Didsbury Point

Amendments Workbook

Project name: Didsbury Point
Project number: 8845
Client: Southway Devco

Further to pre-application discussions with the Local Planning Authority, this booklet has been produced to illustrate amendments made to the consented residential development; Didsbury Point (planning application ref. 135235/FO/2022) as the scheme has progressed to construction stage.

Roof Plan

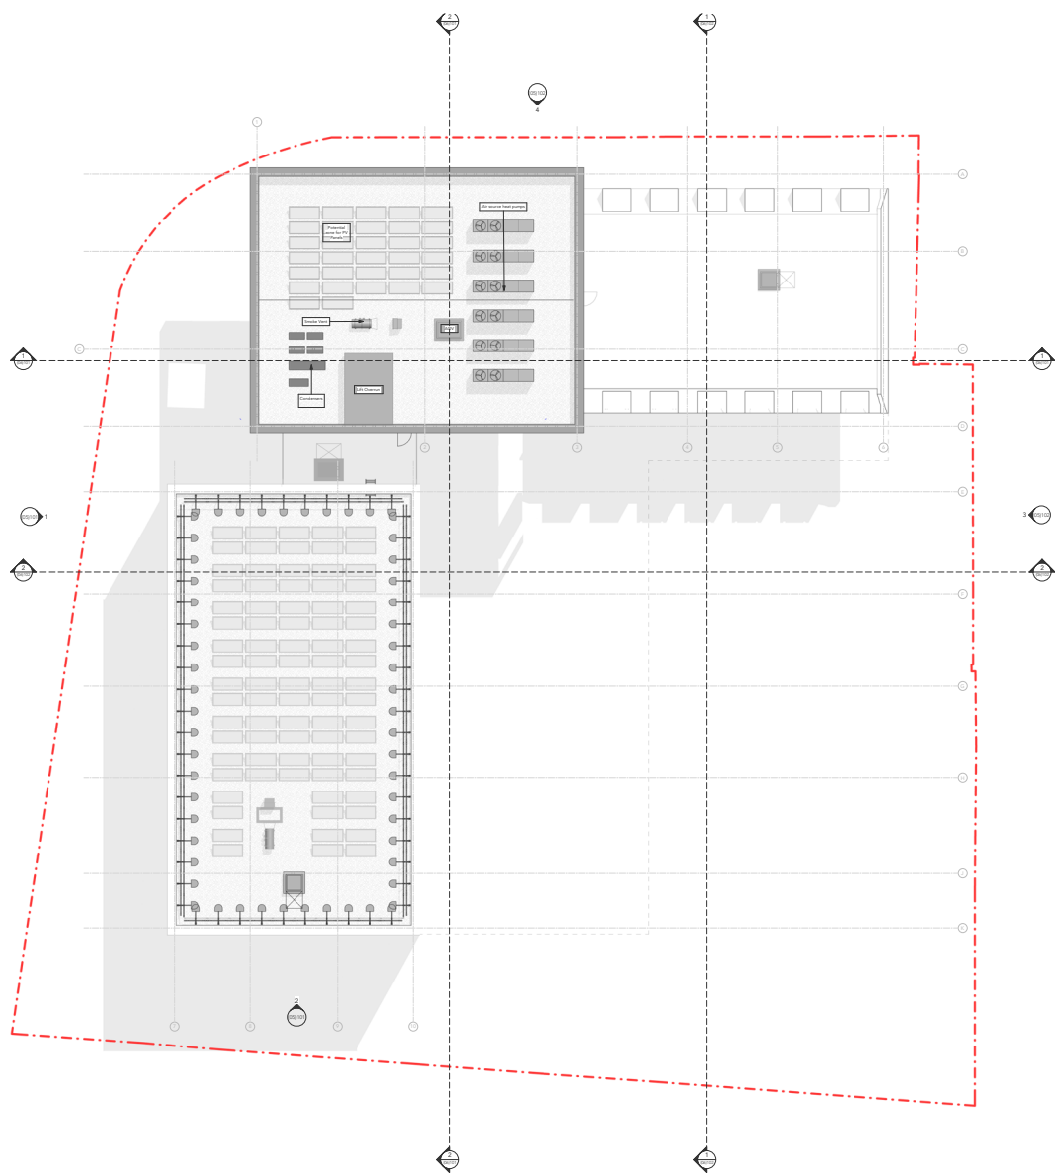
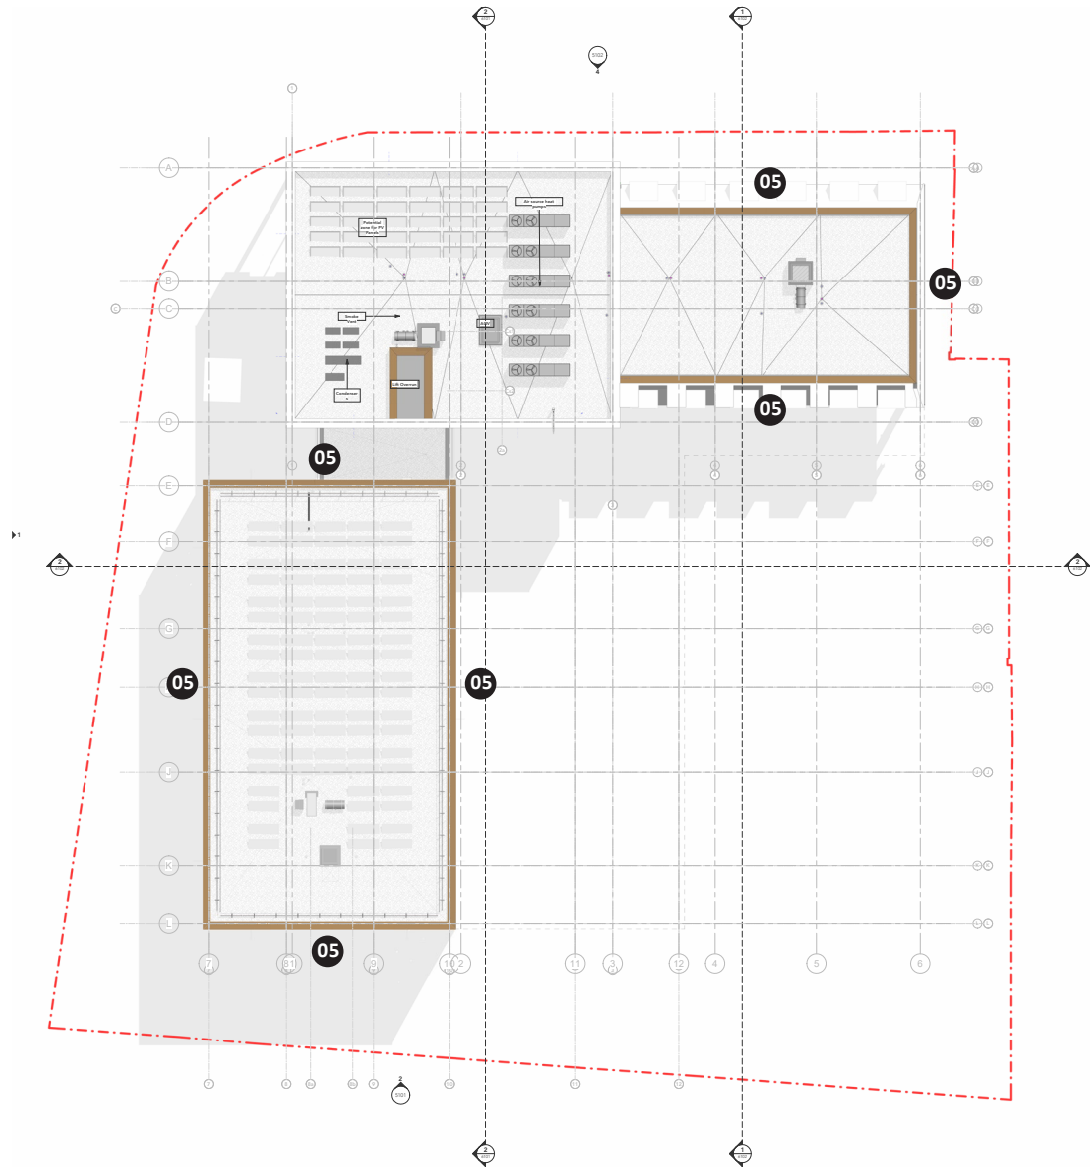
05. Lower block heights increased by 225, 268 or 995mm

Item 5 in Detail - Height Increase to Mansard Roof

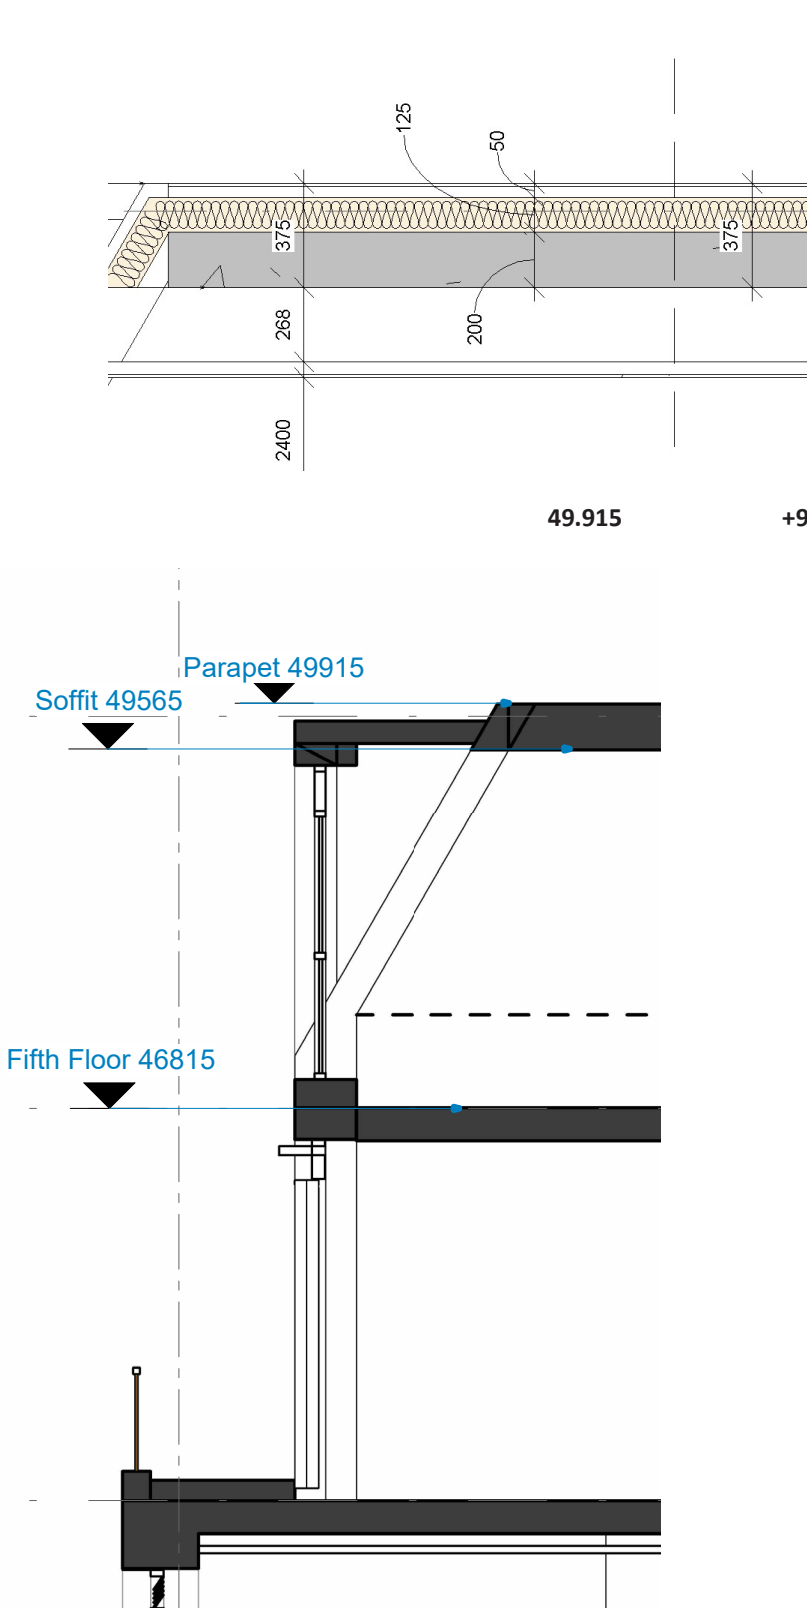
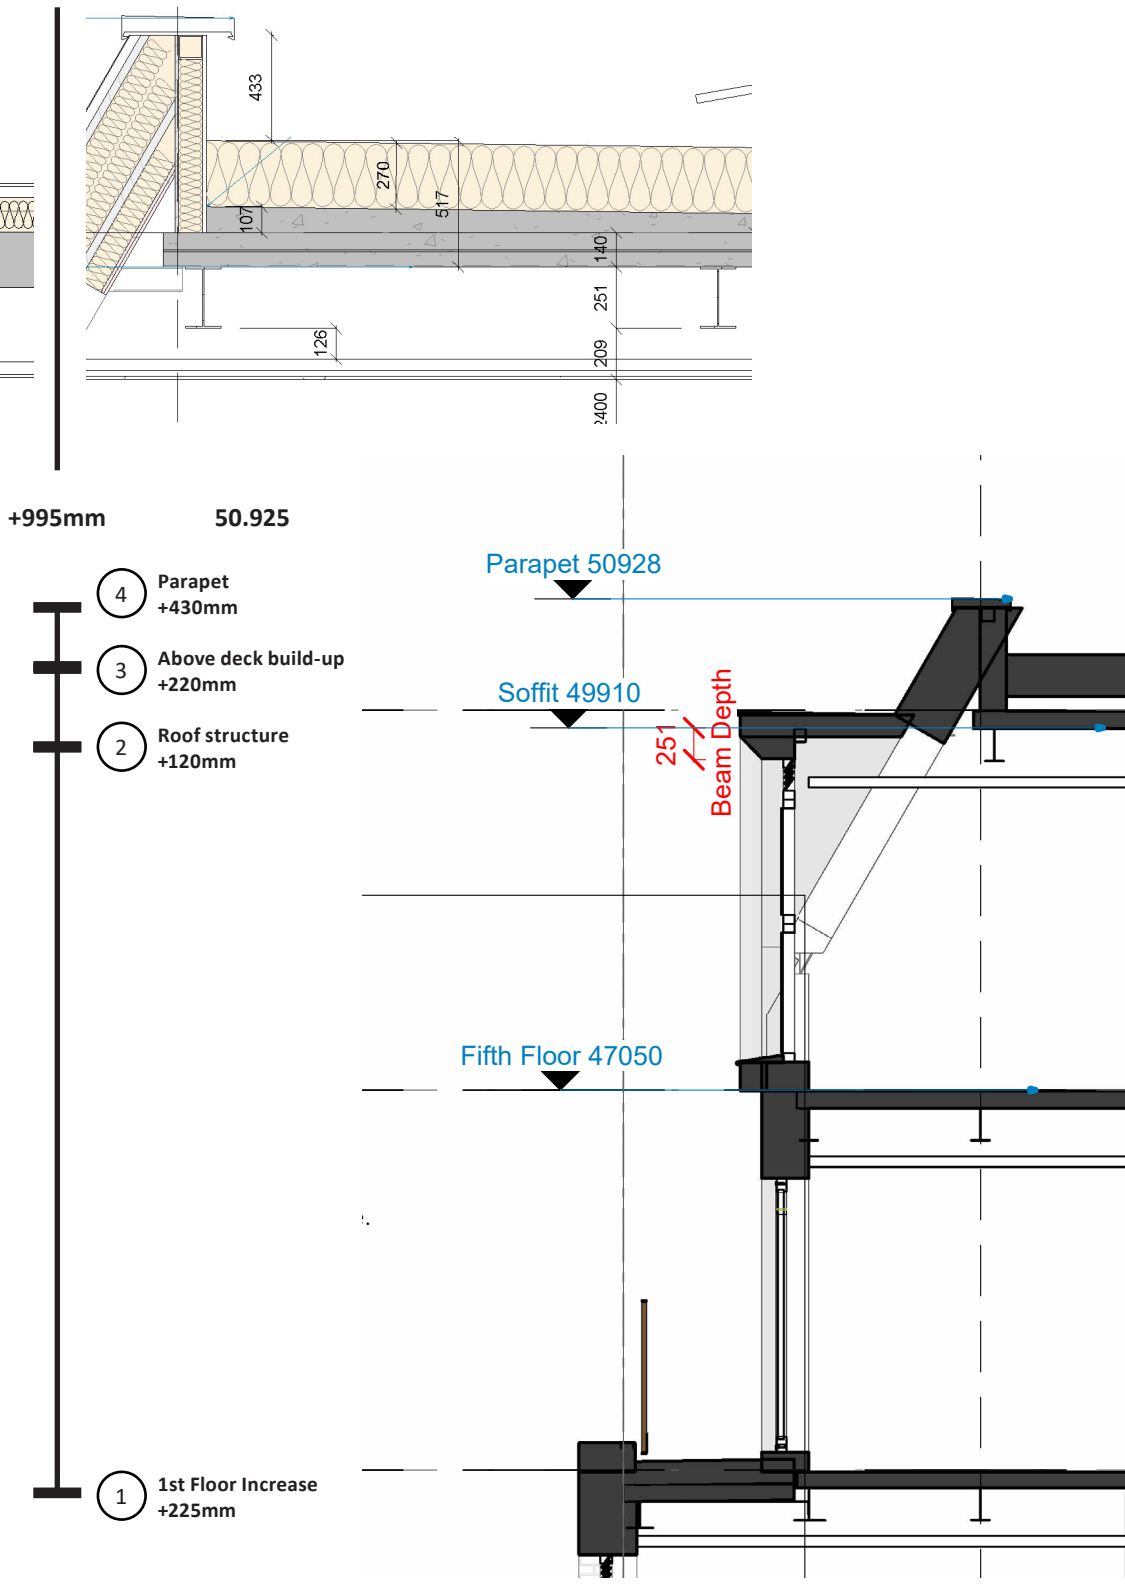
As summarised earlier in the report - the cumulative change in height has arisen from a number of factors during the technical design stage. This has ultimately increased the height to top of mansard structure by 995mm to +50925.

The effect of introducing steel had an adverse impact on the ground floor medical centre ceiling heights. To accommodate the necessary clearance required for mechanical and electrical systems to run below the beams as well as maintaining the correct ceiling height needed for a compliant suite of consultant and treatment spaces to this area, the 1st floor was increased by 225mm (3 brick courses) to provide the necessary clearance. This consequently moved all upper floor levels up 225mm.
- 2

A 200mm thick concrete slab was assumed but changed to a 140mm metal deck on steel frame structure which included beams approximately 250mm deep. The inclusion of steel beams meant the roof deck had to be raised 120mm to ensure services within the duplex apartments could be routed under steel beams.
- 3

It was assumed at planning that the mansard would consist of a warm roof build-up with cladding to wrap over the structure omitting the need for a physical parapet upstand. A screed above the structural slab level is required to form 1 in 40 design fall - this added approximately 100mm to the height required to ensure sufficient fall. Additionally thermal insulation had to be increased from 150mm to 270mm to obtain EPC B rating to duplex apartments and which added 120mm.
- 4

A 430mm high parapet was added to conceal M&E equipment from street level and which benefits the scheme aesthetically from the surrounding streetscape.

7a - ELNW Extract of Plan requirements.

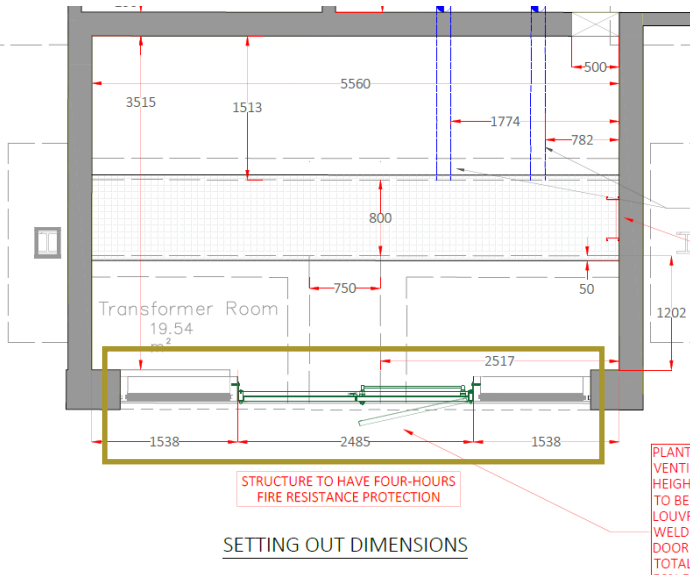
A wider louvred screen arrangement was required as a result of the specific technical requirements given by Electricity North West for the setting out and width of the external double doors.

The transformer room had to sit within a ‘structural bay’ to avoid steel columns being directly within the space. As such the wider louvred screen and doorset were aligned with the two windows directly above at upper floor levels. As illustrated on the elevation extract to the right.

7c - Spaces to were limited to 50m2 to comply with sprinkler design requirements for each space/room. Louvred openings with central double door to maintain continuity and logic to the elevation to these spaces.

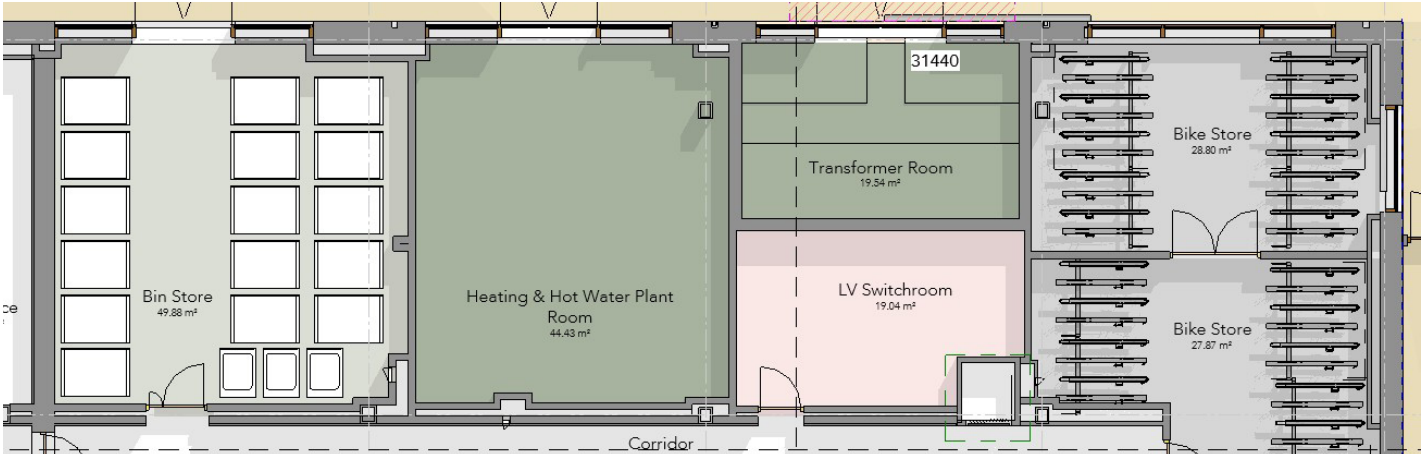
Once the transformer room had been set, the spaces immediately left and right of it where dictated by its set out. There was also a limitation on the size of these spaces to 50sqm to comply with sprinkler design maximum space/room requirements. This set the position of the subsequent internal walls which did not align neatly with the central brick piers. As such, the room positions relative to the external facade shifted, making them more suited a to a door located centrally to each structural bay.

7b - Elevation extract of Transformer room illustrating central door layout.

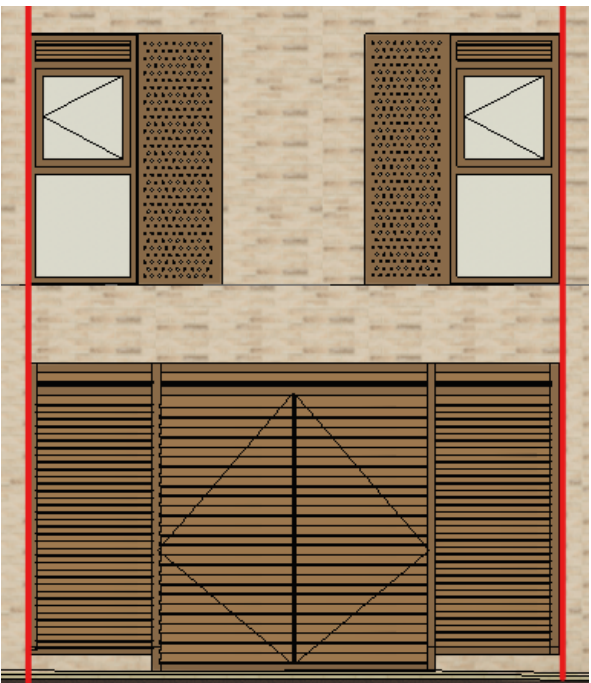
The bin store was located closer to the main entrance and stair core to align with the requirements set by Approved Document H section 6 which dictates the preferred linear distance limit that refuse is to be carried by householders. A central set of doors was also preferred to facilitate manouvering of bins. This further limited the external elevational treatment. to a wider louvred screen arrangement akin to the elevation extract shown to the right.

7d- Column proximity to external curtain wall jambs

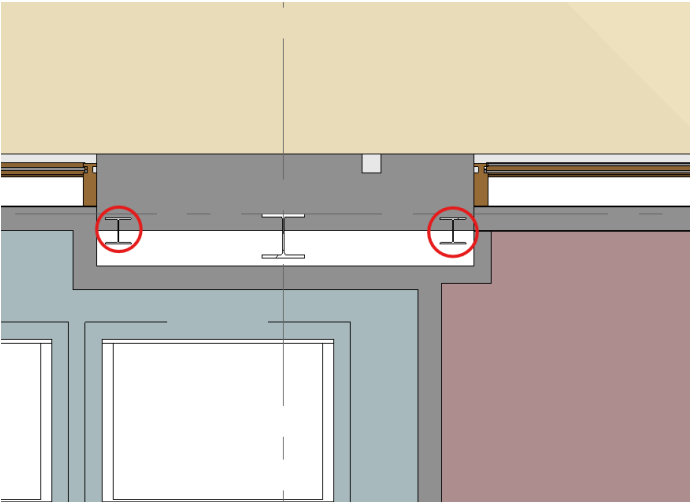
The final element to effect the limiations in respect to the louvred screen arrangement was in relation to the proximity of structural steel columns to the louvred screen jambs. At the time the column positions were fixed and coordinated it was envisaged that they would be encased to maintain the required fire protection.

Impacts resulting from limitations to the fixing back of masonry support angles to encased columns and beams meant that the strategy changed to one of intumescent coating at a late stage. Consequently, a 50mm expansion zone would be required around those columns.

Furthermore, the surrounding internal wall linings also needed to maintain compartmentation and encroached onto the rear of the curtain walls themselves. (see extract to right). In order to mitigate the impact of this; blockwork wall linings were required to the rear of the side screen.
